MECKLENBURG COUNTY HEALTH DEPARTMENT

SITE DISAPPROVAL REPORT
INDIVIDUAL SEPTIC TANK SYSTEM WITH SUBSURFACE,
SOIL ABSORPTION, EFFLUENT DISCHARGE

SUBJECT: APT #7045 (S & T Development Company)
Lot No. 10, 1300 Matthews Mill Road
Reverdy Woods Subdivision
1-7-74

7) ACCURATELY DIAGRAM & DIMENSION LOT

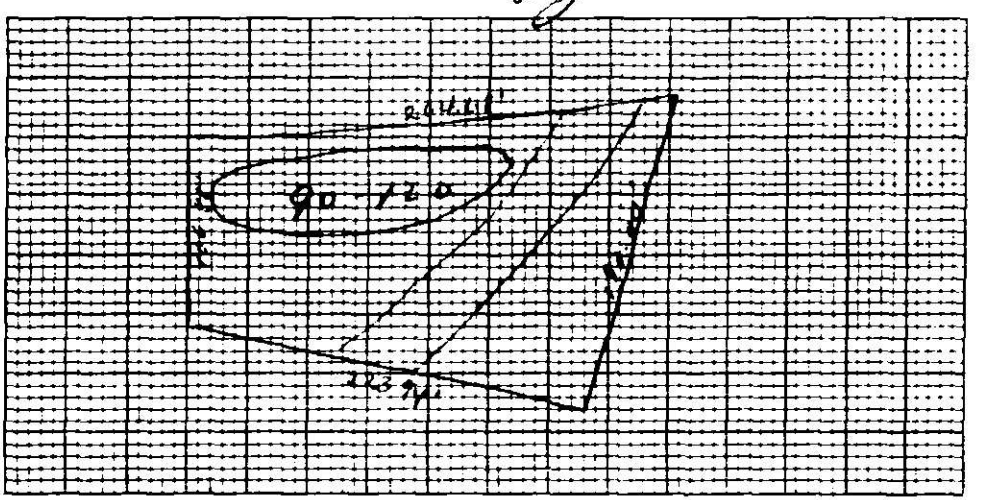
X ON SITE INSPECTION REVEALED LOT TO BE UNSUITABLE FOR THE FOLLOWING REASON(S) 1-7-74 - The lot was found to consist of soils intergradient between the Cecil and Mecklenburg series and soils of the Pacolet series on extremely steep slopes (20+ percent slopes). The intergradient soils contain a small amount of swelling clay minerals. This factor results in inadequately slow permeability and percolation rate (perc. between 90 and 120 min./in.

The areas of steep slope impose extreme physical limitations on the installation of a septic tank system and result in a potential for lateral seepage of effluent.

The lot was found to consist of soils intergradient between the Cecil and Mecklenburg series and soils of the Pacolet series on extremely steep slopes (20+ percent slopes). The intergradient soils contain a small amount of swelling clay minerals. This factor results in inadequately slow permeability and percolation rate (perc. between 90 and 120 min./in.).

The areas of steep slope impose extreme physical limitations on the installation of a septic tank system and result in a potential for lateral seepage of effluent.

Based on this investigation it is recommended that the lot be disapproved for installation of a conventional septic tank system.

PLOT OF SYSTEM

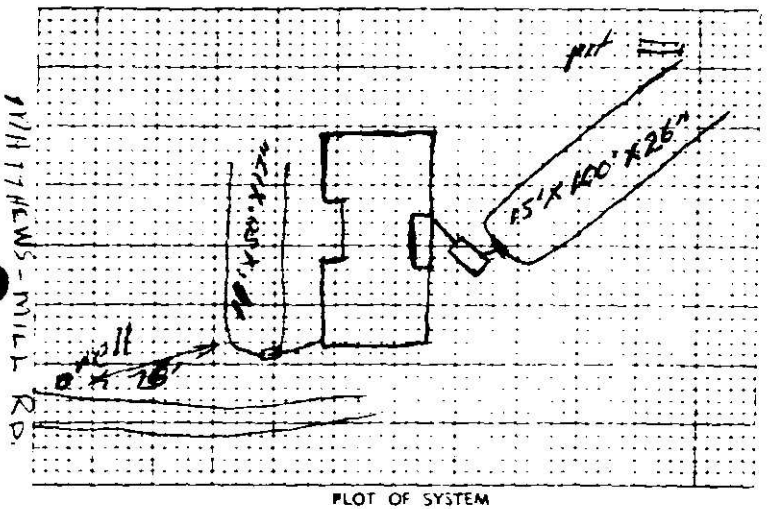
Comments: PLUMBING TO BE RELOCATED.
